ST. TAMMANY PARISH

**Addendum No.:** 2

**Bid#:** 327-00-18-50-2

**Project Name:** Safe Haven Renovations Quad A

**KEYNOTES:**

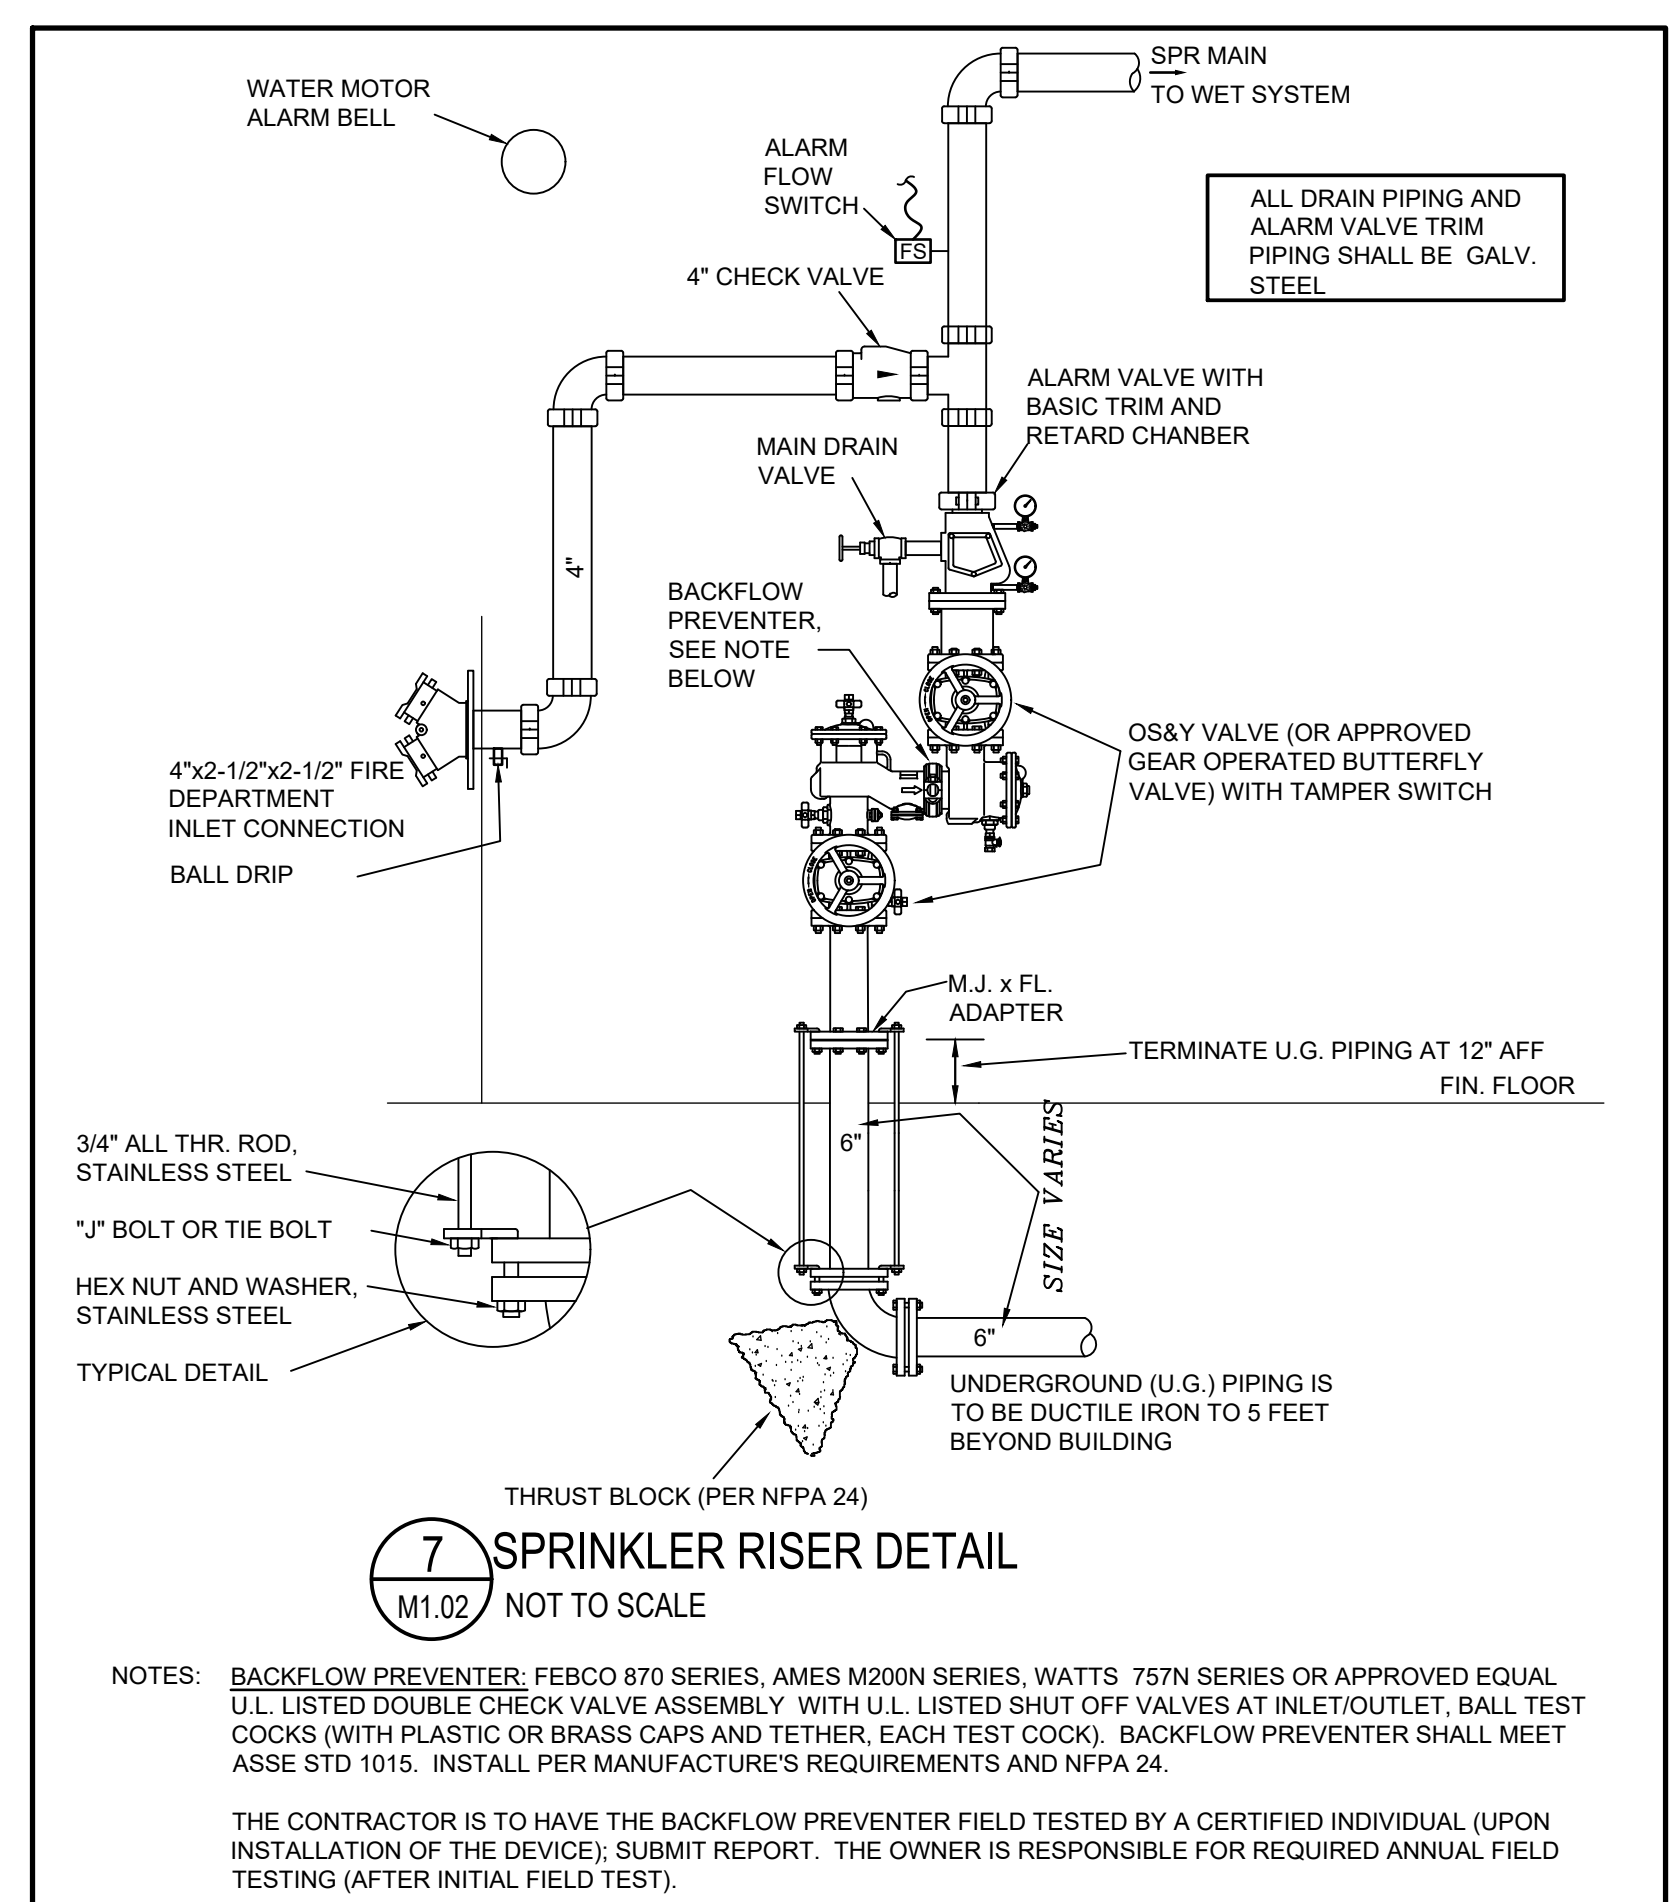
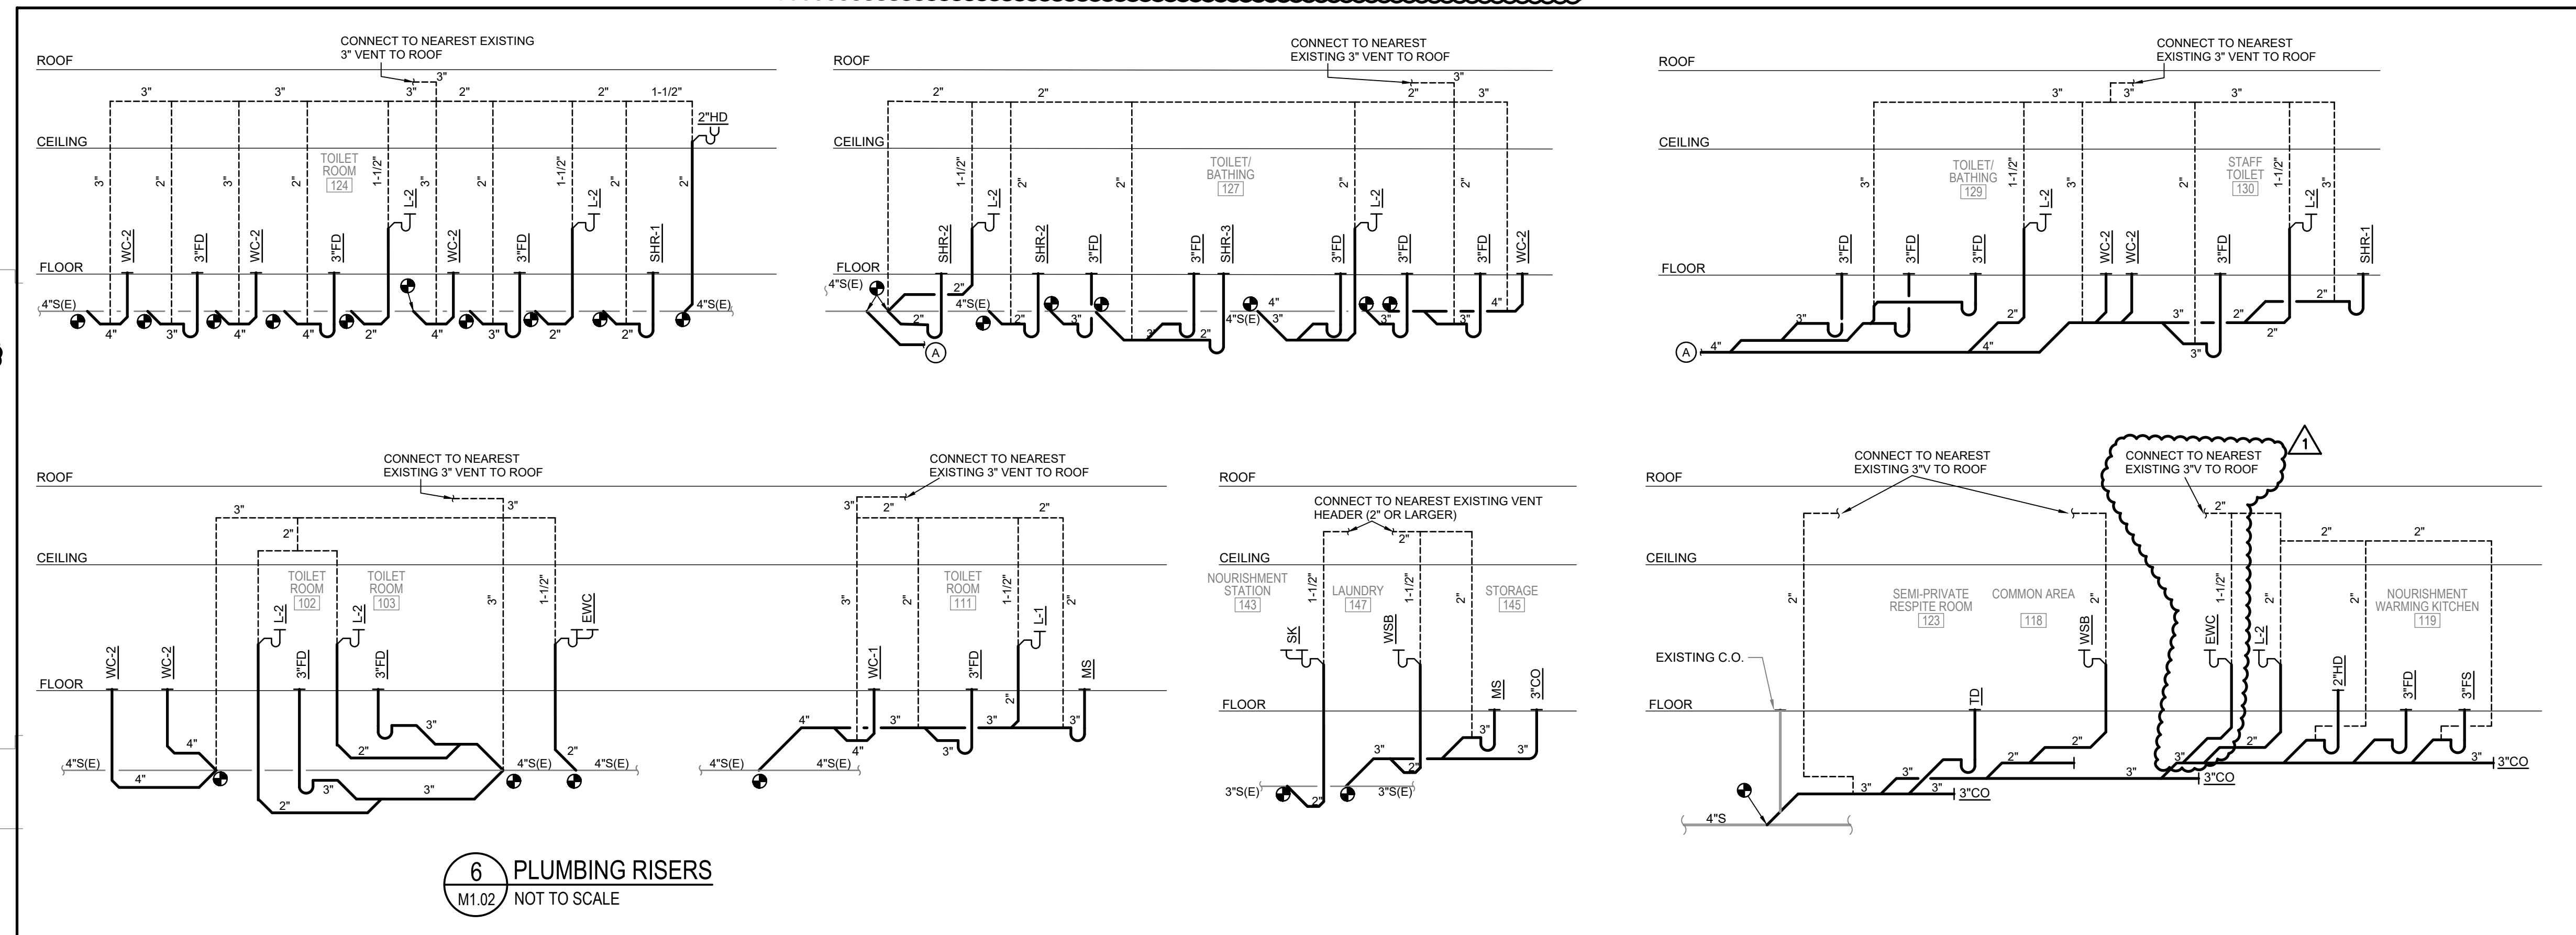
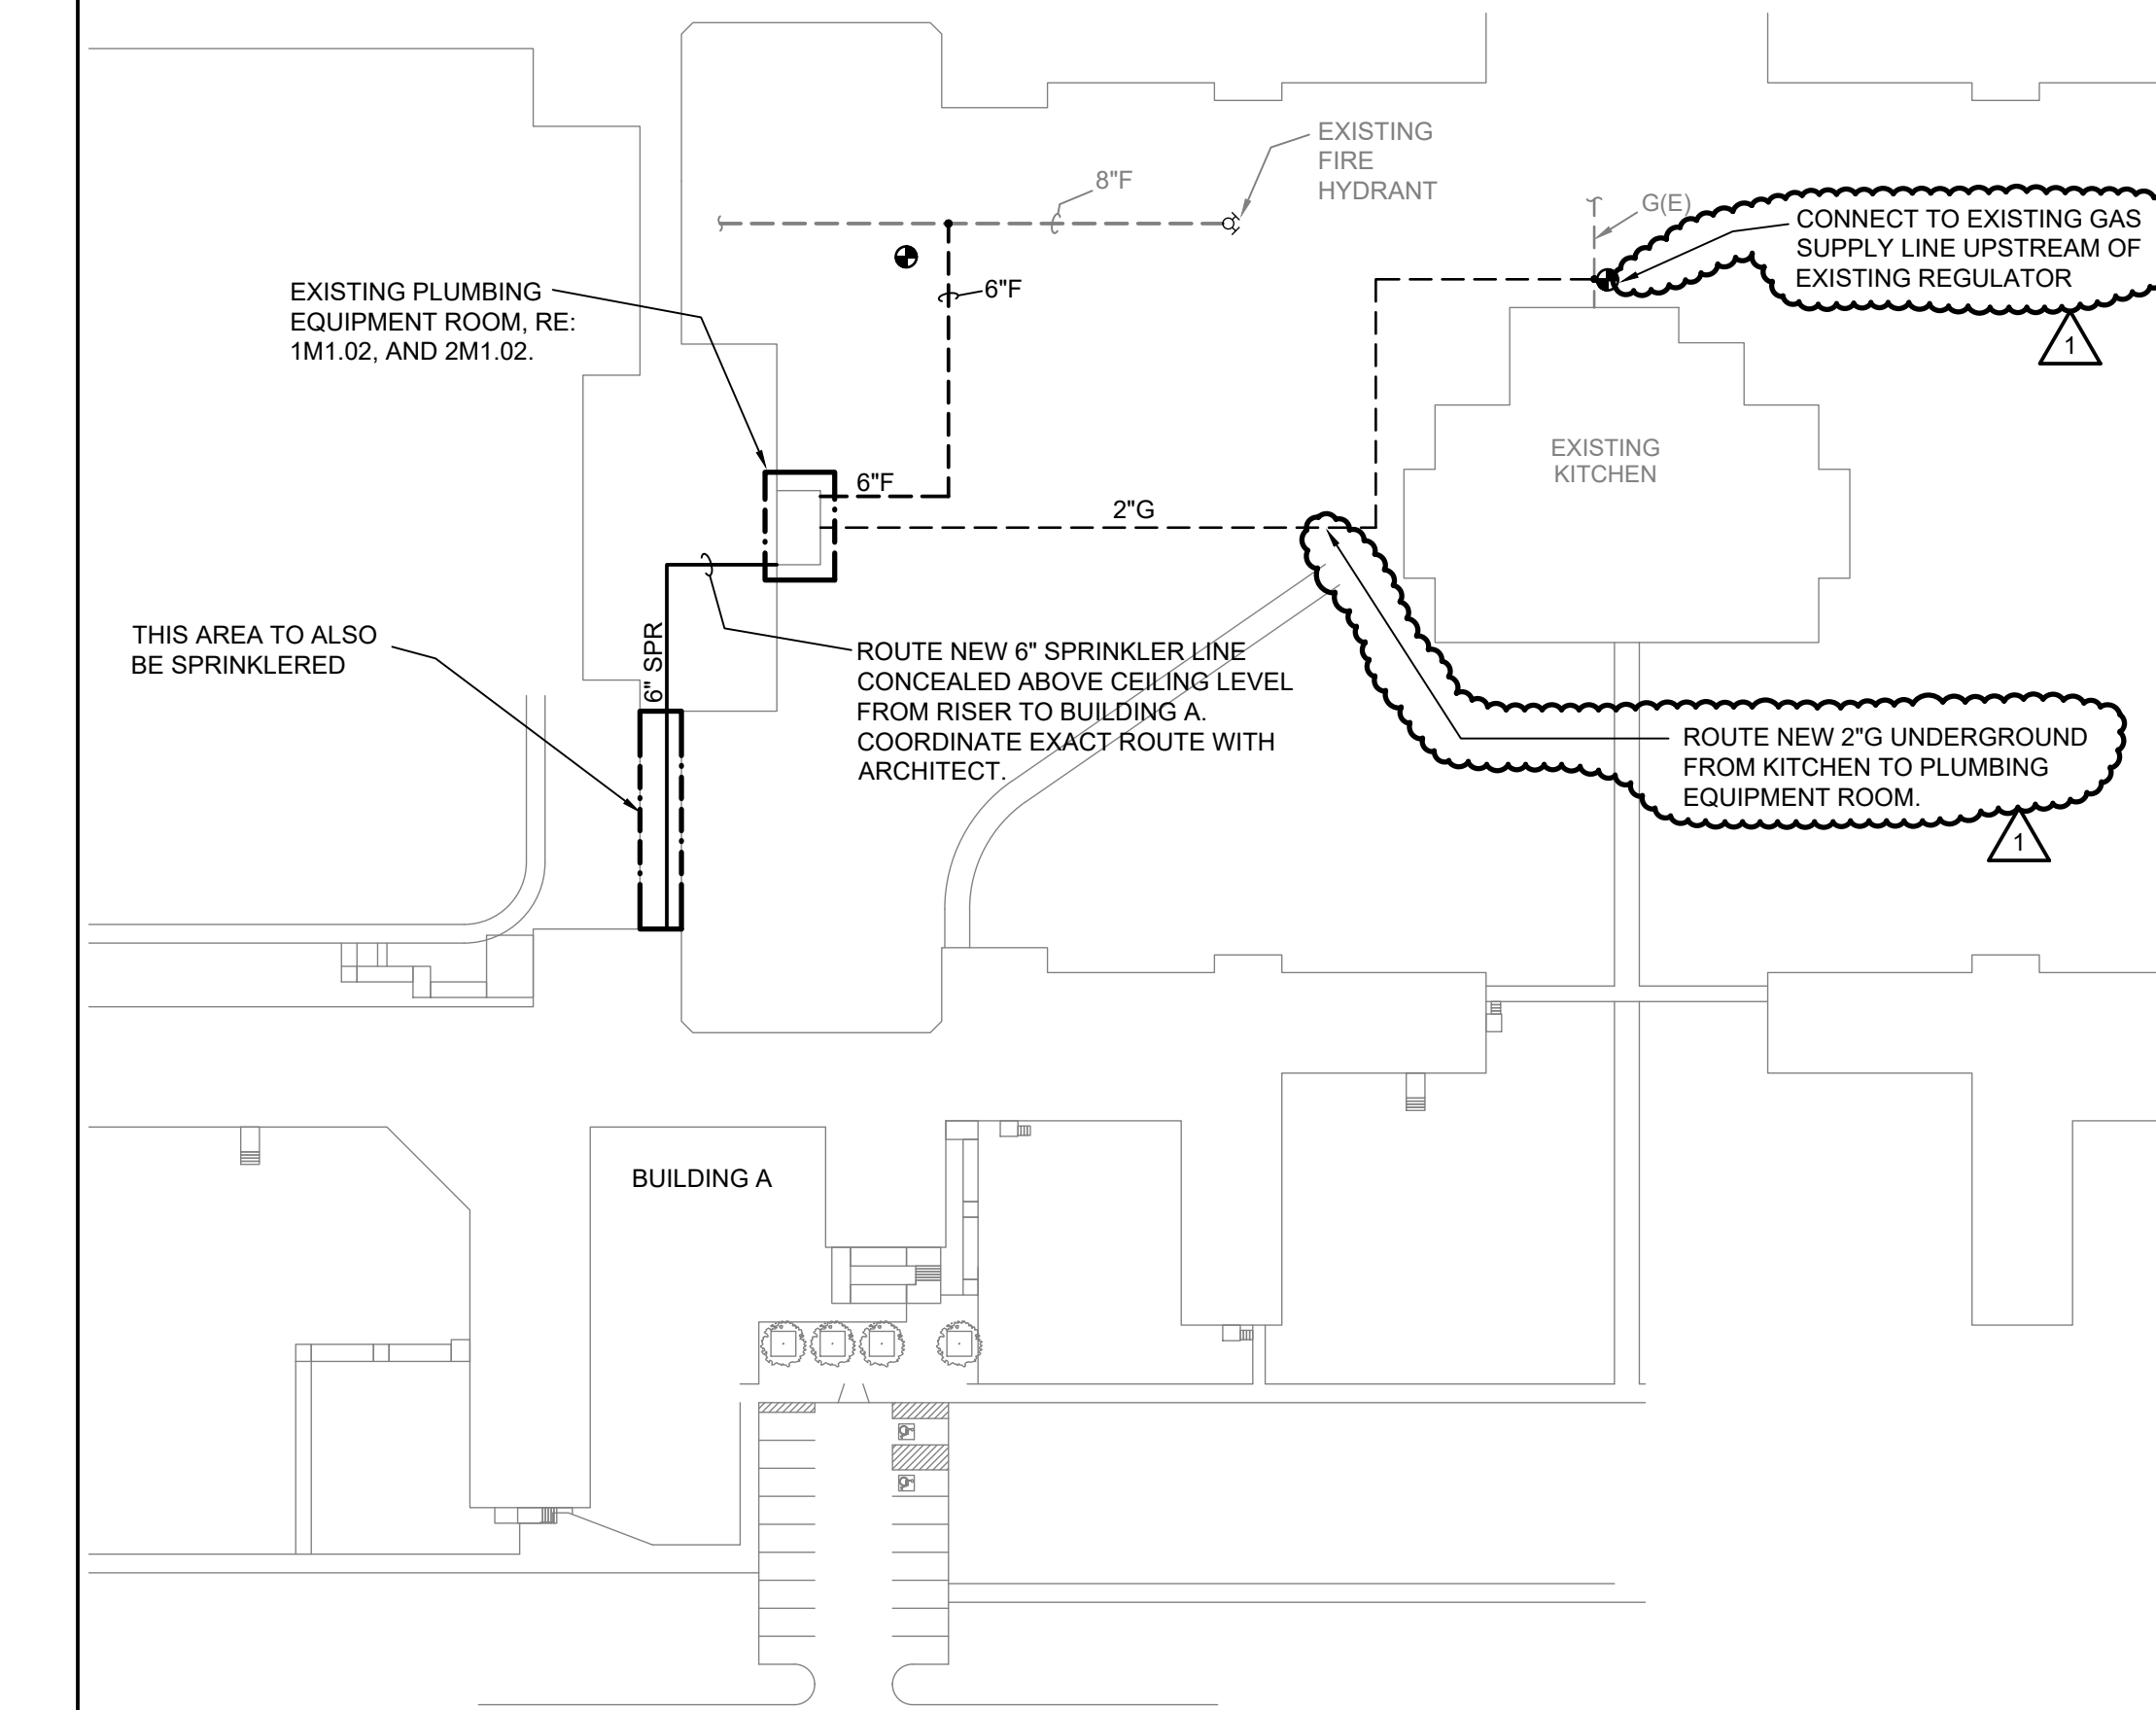
12. At Section 11 – Drawings, **DELETE** sheet M1.02 and **ADD** sheet M1.02 Rev.1 dated 6 May 2019. Updated water heater details to comply with new specification of the water heaters, added notes to the underground gas pipe routing for clarity purposes and revised the plumbing riser diagram to include the new electric water cooler. (Attached)
